Re: Ithaca Falls Overlook Brownfield Cleanup Project
Amendment to June 2014 Quality Assurance Project Plan

ITHACA FALLS OVERLOOK EPA BROWNFIELD CLEANUP PROJECT

REMEDIAL EXCAVATION PLAN

Sheet Number
3A

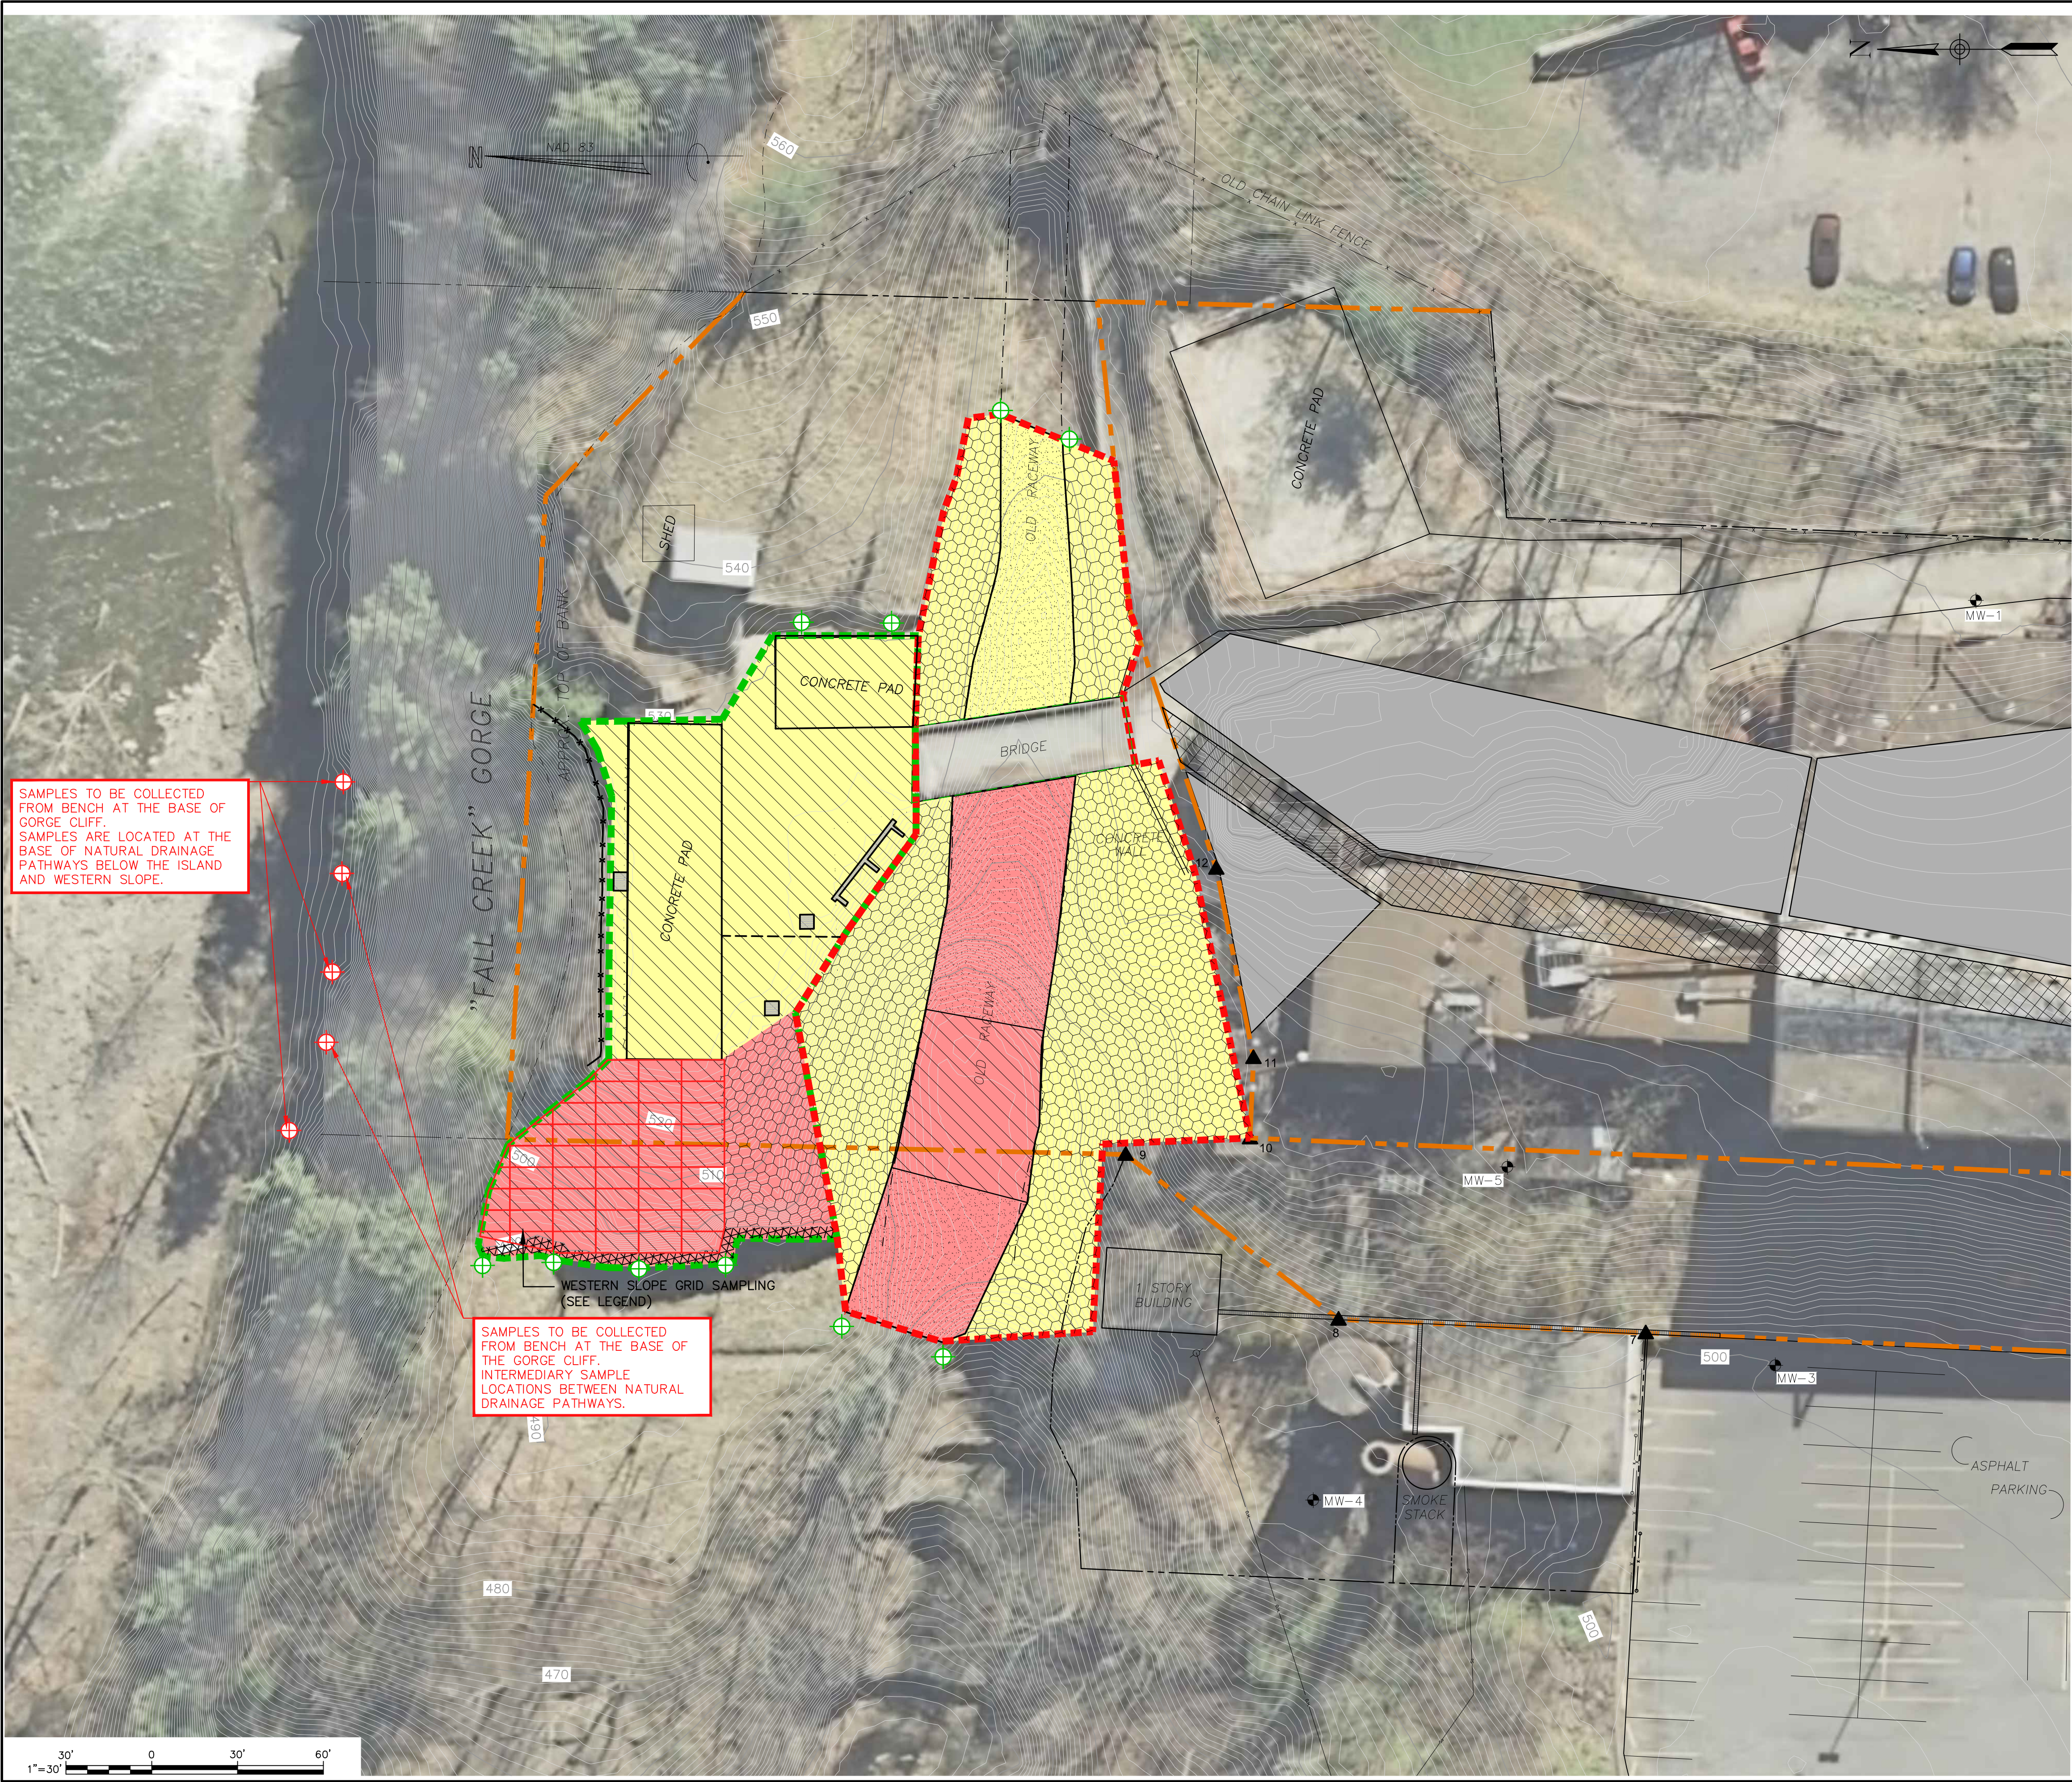
The June 2014 QAPP identified 10 perimeter clearance soil samples to be analyzed for target analyte list (TAL) metals via EPA 6010 B (refer to Figure 3 of the June 2014 QAPP). The number and location of samples was based on the assumption that soils would be removed to rock. Portions of the western slope of the island and the island top will have native soils remaining following the remedial excavation. These native soils are intermixed with fractured shale that overlies the consolidated bedrock of the island. Removal to rock is not necessary in all areas to eliminate lead contaminated soil in order to meet the lead Site Cleanup Objective of 400 ppm. There is an identifiable visual distinction between industrial soils and native unconsolidated material (soil and weathered rock). The limits of the remedial excavation are based on the presence of native soils and will be confirmed with sampling of the remnant soil. In some areas native soils are not present below industrial soils. In these areas the industrial soils will be removed to bedrock eliminating the availability of remnant soils to be sampled.

In some areas, a layer of native soil has been observed below the industrial soils that have been removed from the western island slope and island top. These native soils are visually distinctive from the industrial soils that have been removed from the island top and western slope. The native soils are intermixed with fractured shale. In contrast, in some areas the industrial soils are

underlain directly by consolidated bedrock (without the presence of native soils). If there is remnant soil following the remedial construction it will be sampled. Samples will not be collected if removals occur to consolidated bedrock (as opposed to fractured shale with intermixed native soil). In areas where bedrock is not encountered, a 10' by 5' grid network is proposed to assess remaining native soils/fractured shale following remedial construction. One composite sample will be collected from each grid as depicted on the attached revised Figures 3-A/B. Each composite sample will consist of five subsamples. The actual number of composite samples collected will be based on the final dimensions of the remedial excavation and determination of the presence of consolidated bedrock. Based on the assumed configuration as presented on Figures 3-A/B, approximately 43 composite samples would be collected from the western slope and 88 samples from the island top. Each sample will be analyzed for total lead. It should be noted that some grids depicted on Figures 3-A/B may be excavated to bedrock precluding the opportunity for sample collection. Areas that are excavated to consolidated bedrock will also be manually swept and vacuumed with a heavy duty pneumatic vacuum truck to eliminate remnant material.

It is proposed that Figures 3-A/B replace the existing Figure 3 of the June 2014 QAPP to represent post-excavation clearance soil sampling locations. It should be noted that additional samples utilized for waste characterization/internal site assessment will be collected as part of the remedial construction project that are not depicted on Figures 3-A/B. All sample results and locations will be presented as part of the Construction Completion Report. All revised samples presented herein will be collected in accordance with the procedures outlined in the June 2014 QAPP. The following post-excavation clearance samples are proposed. Samples will only be collected in areas where bedrock is not encountered (i.e., native soil remains intermixed with fractured shale).

Revised Post-Excavation Clearance Soil Sampling			
Location	Number of Samples	Type of Sample	Analysis
Western Island Slope	43*	Composite	Total Lead
Island Top	88*	Composite	Total Lead
Downgradient Perimeter of Western Island Slope	4	Grab	TAL Metals
Up gradient Island Perimeter (East of Island)	2	Grab	TAL Metals
Downgradient Western Raceway	2	Grab	TAL Metals
Up gradient Eastern Raceway	2	Grab	TAL Metals
Fall Creek Gorge	5	Composite	TAL Metals VOCs
<u>Notes</u> All samples to be collected from 0-2 inches below grade. Each composite sample to consist of five sub-samples. *Some grids along the western island slope and island top depicted on Figures 3-A/B may be removed to bedrock. Areas removed to bedrock will not be sampled. The actual number of samples collected along the western island slope and island top will be dependent upon final dimensions of the excavation activities and presence of remaining soil on the slope.

Sheet Number
3B

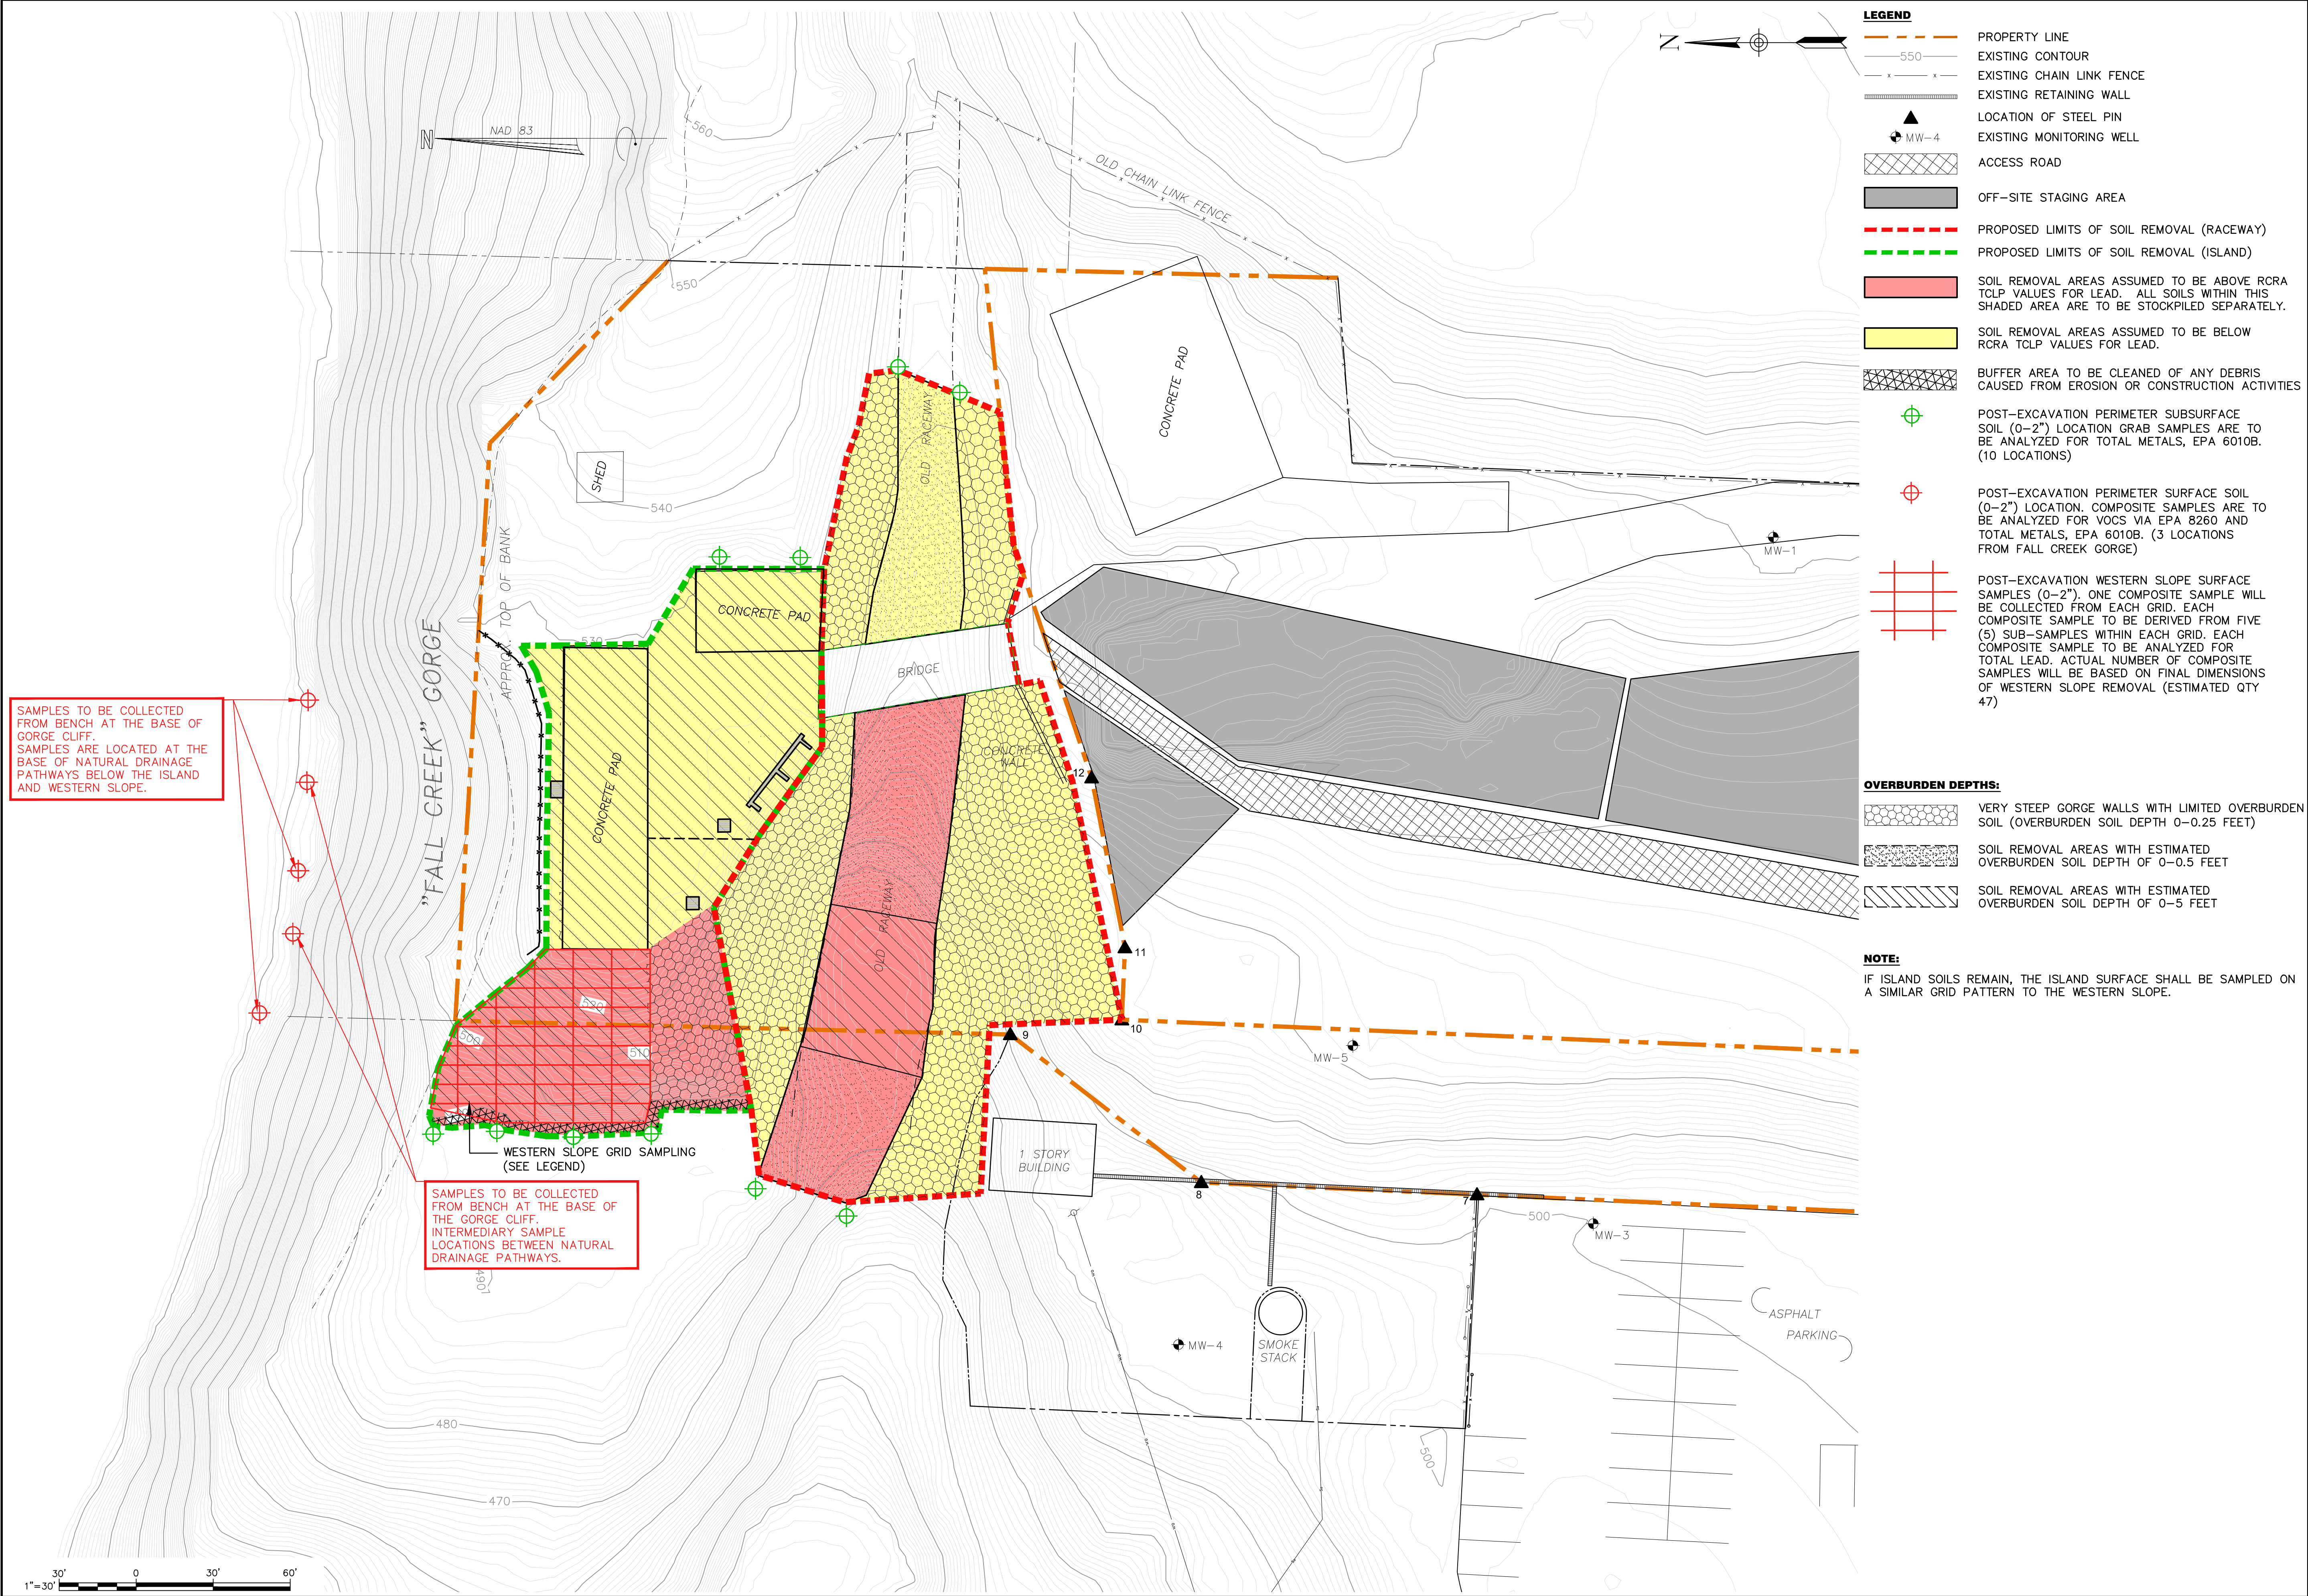
Additional lead impacted soils have been encountered on the northern portion of the island. The June 2014 QAPP included removal of lead impacted soil on the island to an existing chain link fence on the north side of the island. A thin layer of soil is present north of the fence that was tested for lead and was subsequently removed. Five additional samples are proposed to be collected within the Fall Creek gorge to verify off-site conditions north of the island. These samples will consist of composite soil samples each consisting of five sub-samples. The samples collected from the gorge will be analyzed for TAL metals (6010 B) and volatile organic compounds (VOCs) via EPA 8260. Additional sampling will be proposed as needed based on these initial Fall Creek gorge screening samples.
